ZONING CHANGE REVIEW SHEET

CASE: C14-2024-0180 (1211 East 52nd Street Zoning) DISTRICT: 4

MEMORANDUM

From: Nathan Aubert, P.E.
To: Kathy Smith, P.E., PTOE
Date: June 23, 2023
Subject: 51st and Cameron – Zoning Transportation Analysis (C14-2023-0003)

Figure 2. Conceptual Site Driveways (Figure taken from ZTA report); Driveways A, B, C, D are for site access. Driveways 1-4 are service driveways.

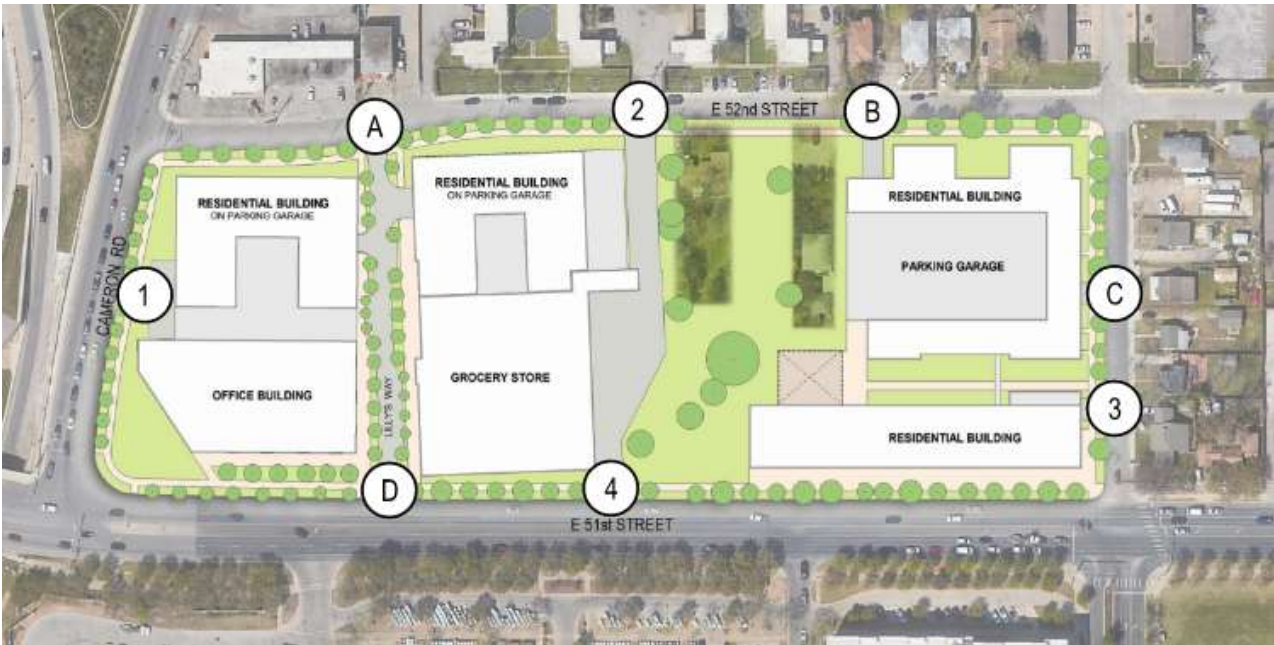
The site proposes four full purpose driveways on 52nd St (Driveways A, B), Lancaster Ct (Driveway C), and E 51st St (Driveway D). The site proposes four additional service driveway locations on (1) Cameron Rd, (2) 52nd St, (3) Lancaster Ct, and (4) E 51st St. A conceptual site plan showing proposed driveway locations can be seen in Figure 2.

1. Provide no more than one site and one service driveway on E 51st St (designated driveways D, 4). Both driveways are proposed to operate as full purpose and will be reviewed for compliance to City codes, ordinances, criteria manual, etc. at the time of the Site Plan application.

2. Provide no more than one service driveway onto Cameron Rd (designated driveway 1), provided it can meet design requirements and does not require a waiver from the Transportation Criteria Manual (TCM). The driveway is proposed to operate as full purpose and will be reviewed for compliance to City codes and ordinances at the time of the Site Plan application.

3. Provide no more than two site and one service driveways on E 52nd St (designated driveways A, B, 2). The driveways are proposed to operate as full purpose and will be reviewed for compliance to City codes and ordinances at the time of the Site Plan application.

4. Provide no more than one service driveways on Lancaster Ct (designated driveways C,3). The driveway is proposed to operate as full purpose and will be reviewed for compliance to City codes and ordinances at the time of the Site Plan application.
